09028 Version 14

Warranty Extension: MIL Comes On With DTCs P0301 thru P0304

Supersedes 13-081, dated February 03, 2018, to revise the information highlighted in **yellow**.

54K PISTON

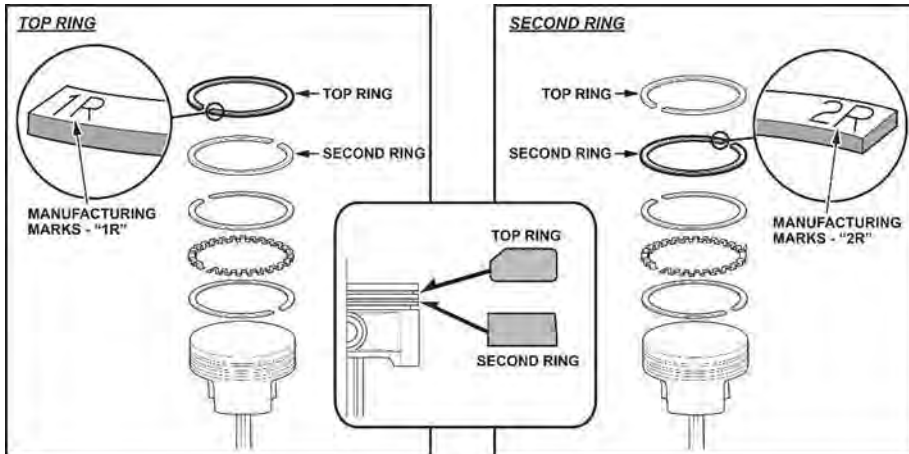
An image was add to REPAIR PROCEDURE B – PISTON CLEANING AND RING REPLACEMENT, Piston Cleaning and Ring Replacement Procedure.
